SUBJECT: FORT CALHOUN STATION, UNIT 1 - STAFF ASSESSMENT OF INFORMATION PROVIDED PURSUANT TO TITLE 10 OF THE *CODE OF FEDERAL REGULATIONS* PART 50, SECTION 50.54(f), SEISMIC HAZARD REEVALUATIONS FOR RECOMMENDATION 2.1 OF THE NEAR-TERM TASK FORCE REVIEW OF INSIGHTS FROM THE FUKUSHIMA DAI-ICHI ACCIDENT (TAC NOS. MF3735)

Enclosure:  
Staff Assessment of Seismic  
Hazard Evaluation and Screening Report

STAFF ASSESSMENT BY THE OFFICE OF NUCLEAR REACTOR REGULATION  
RELATED TO SEISMIC HAZARD AND SCREENING REPORT  
FORT CALHOUN STATION  
DOCKET NO. 50-285

Figure 3.3- 1 Plot of Staff's and Licensee's Base Case Shear-Wave Velocity Profiles for the FCS site

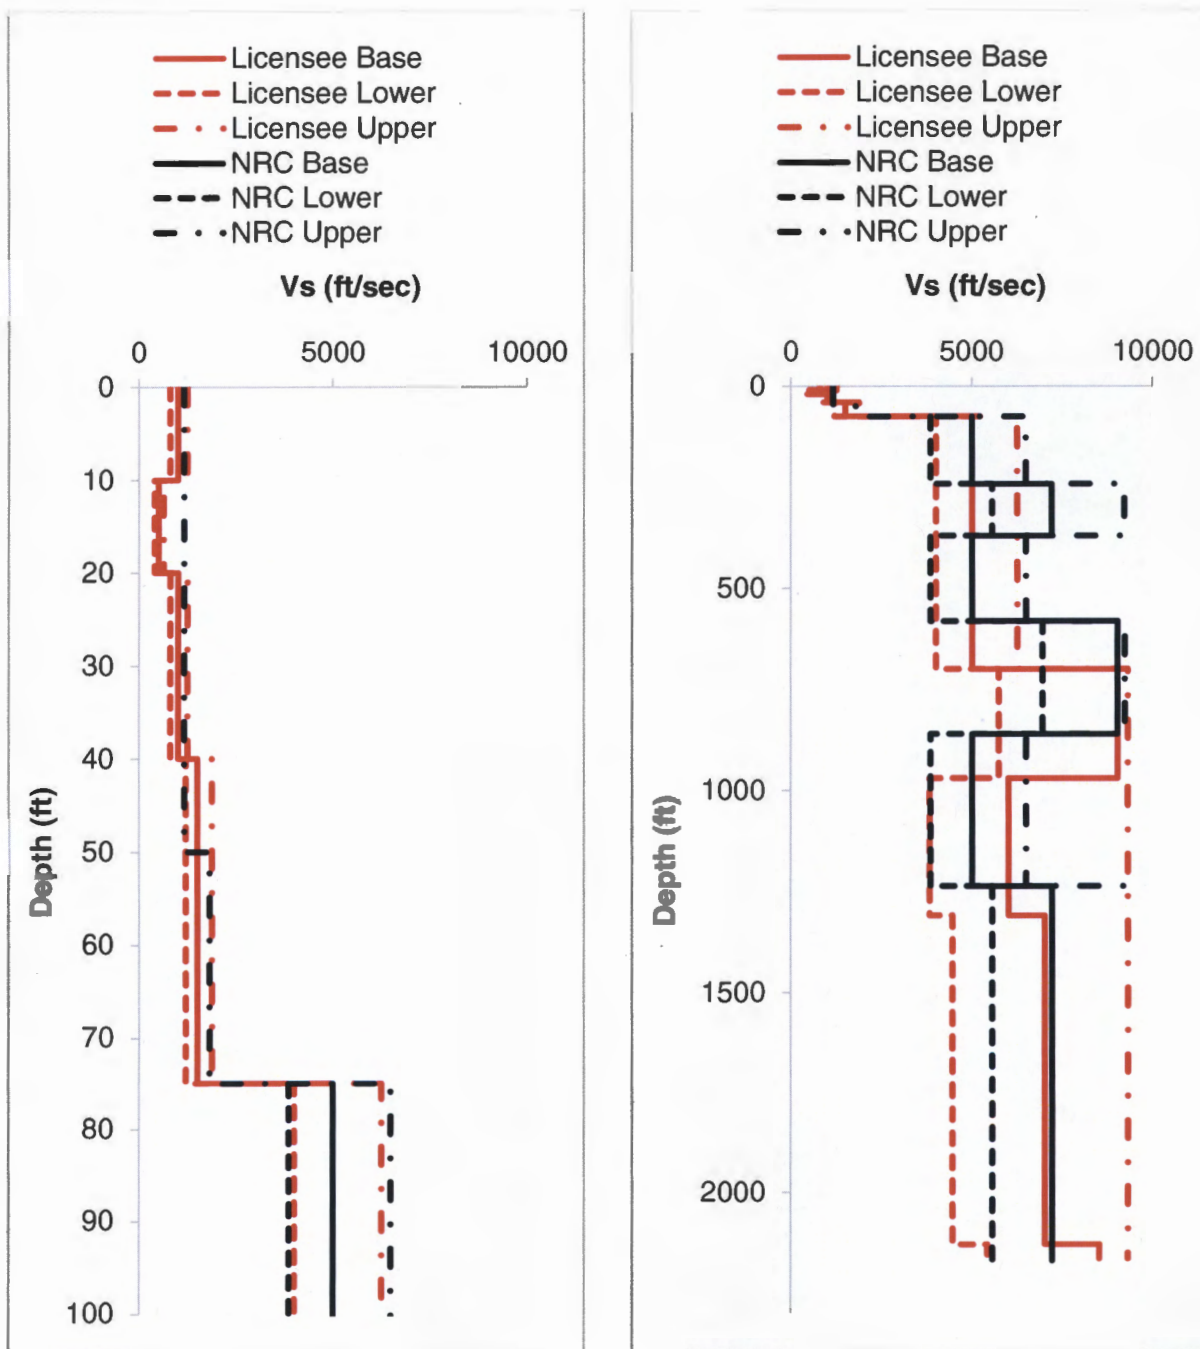
To characterize the subsurface geology, the licensee developed three site base case profiles. The licensee's middle, or best estimate, profile was developed using measured shear-wave velocities to a depth of 700 ft (213 m). Below this depth, the licensee used data from nearby water, oil and gas wells to develop the shear wave velocities. Consistent with the SPID, the licensee developed the upper and lower base case profiles using a scale factor of 1.25 in the upper 700 ft (213 m) and 1.57 below that depth. Figure 3.3-1 of this assessment shows the licensee's three shear-wave velocity base case profiles.

Following guidance provided in the SPID for sites with little at-site information, the NRC staff independently determined best-estimate, upper and lower base case profiles for the FCS site. To develop upper and lower base case profiles, the NRC staff used a scale factor of 1.57. The staff's base case shear-wave velocity profiles are shown along with the licensee's base case profiles in Figure 3.3-1 of this assessment. The staff's shear wave velocity profiles are similar to those submitted by the licensee with only a minor difference in the estimated depth to individual

sedimentary rock formations and the staff's interpretation of a shear wave velocity estimate of 7200 fps (2195 m/s) for a 130 ft (40 m) thick layer at a depth of 170 ft (52 m). The staff's estimate of 7200 fps (2195 m/s) is based on shear wave velocity estimates of similar rock formations.

**Figure 3.3- 2 Plot Comparing the Staff's and the License's Median Amplification Functions and Uncertainties for two input loading levels for the FCS site**

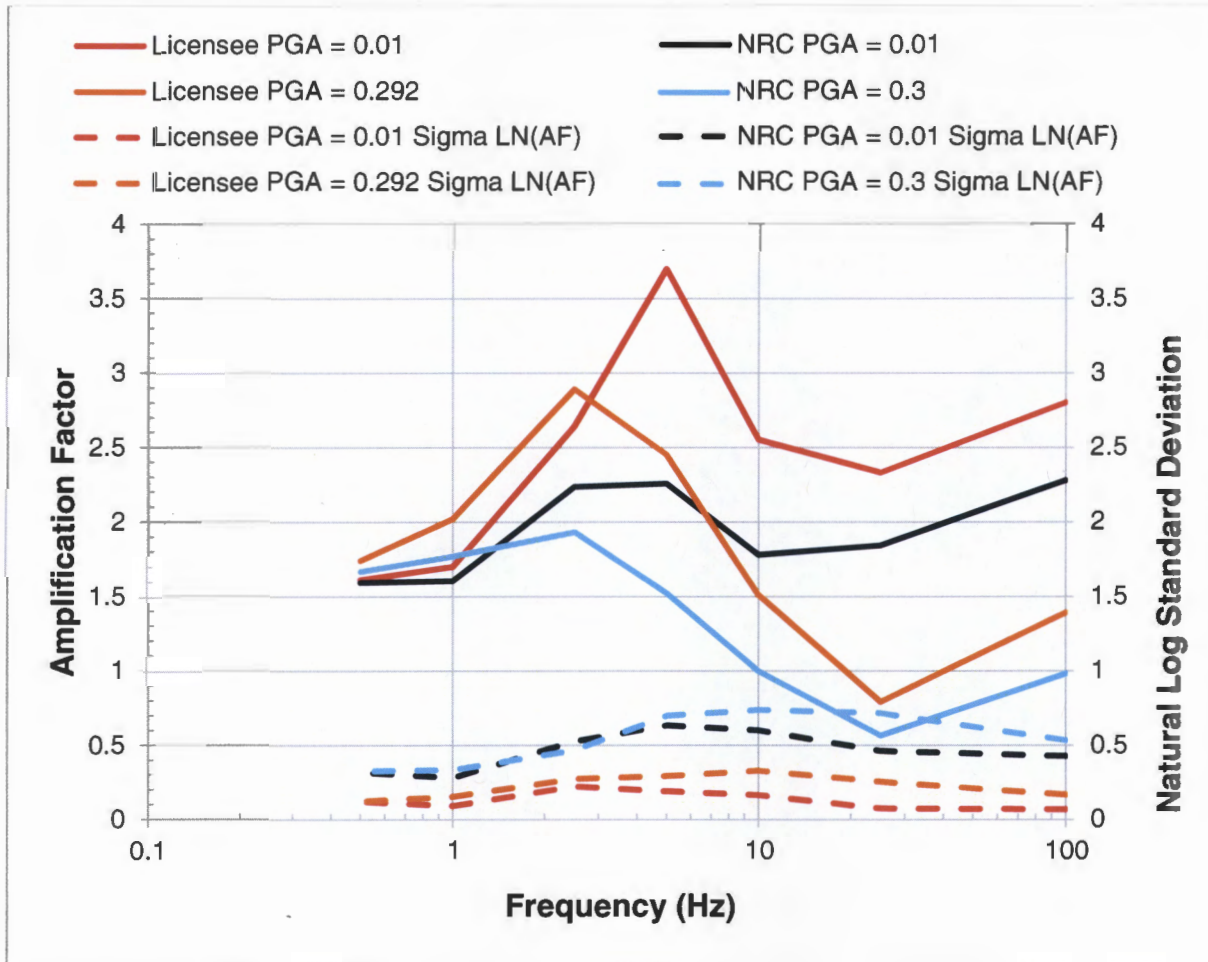
Figure 3.3-2 of this assessment shows a comparison of the staff's and the licensee's median site amplification functions and associated uncertainties ( $\pm 1$  standard deviation) for two of the eleven input loading levels. Both the staff's and licensee's site amplifications are similar in shape; however, the licensee has a higher peak amplification at 5 Hz compared with the staff's result. The licensee's larger peak amplification is due to differences in the staff's and licensee's velocity profiles as well as differences in the range of kappa values used by the NRC staff and licensee for the site response analyses.

Figure 3.3-3 Plot Comparing the Staff's and the Licensee's Mean Control Point Hazard Curves at a Variety of Frequencies for the FCS site

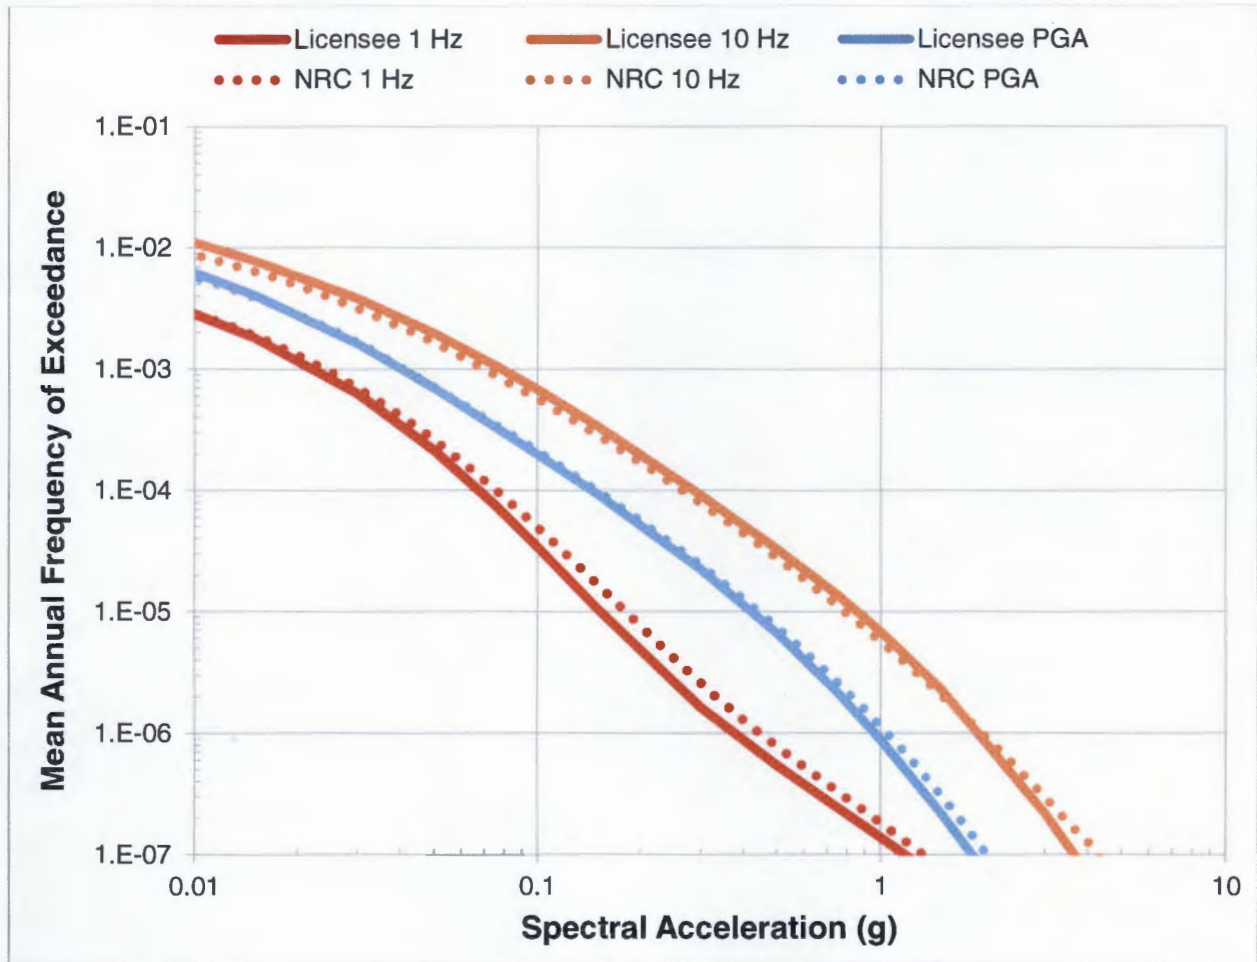
As shown in Figure 3.3-3 of this assessment, differences in site response analyses have only a minor impact on the control point seismic hazard curves and the resulting GMRS, discussed below. Overall, the control point seismic hazard curves developed by the NRC staff are similar to those developed by the licensee. Appendix B of the SPID provides guidance for performing site response analyses, including capturing the uncertainty for sites with less subsurface data; however, the guidance is neither entirely prescriptive nor comprehensive. As such, various approaches in performing site response analyses, including the modeling of uncertainty, are acceptable for the 50.54(f) response.

Figure 3.4-1 Comparison of the Staff's GMRS with Licensee's GMRS and the SSE for the FCS site

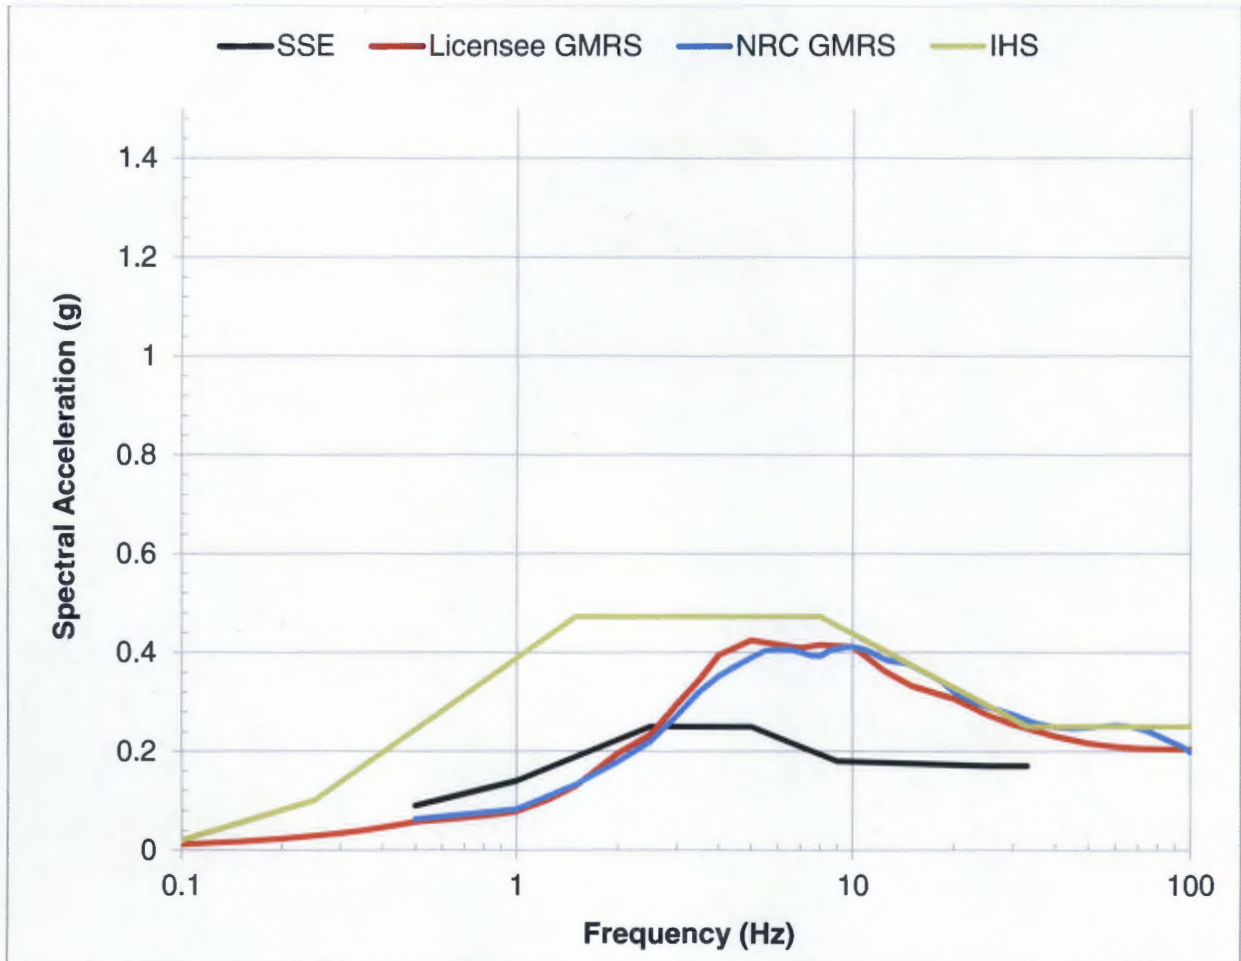
The NRC staff independently calculated the  $10^{-4}$  and  $10^{-5}$  UHRS using the results of its confirmatory PSHA and site response analysis, as described in Sections 3.2 and 3.3 of this NRC staff assessment, respectively. Figure 3.4-1 of this assessment shows a comparison of the GMRS determined by the licensee to that determined by the NRC staff.

As shown in Figure 3.4-1 below, the licensee's and staff's GMRS are very similar. As described above in Section 3.3, the NRC staff concludes that these minor differences are primarily due to the differences in the site response analyses performed by the licensee and NRC staff. The NRC staff performed both a PSHA and site response confirmatory analysis and achieved results consistent with the licensee's horizontal GMRS. As such, the staff concludes that the GMRS determined by the licensee adequately characterizes the reevaluated hazard for the FCS site. Therefore, this GMRS is suitable for use in subsequent evaluations and confirmations, as needed, for the response to the 50.54(f) letter.
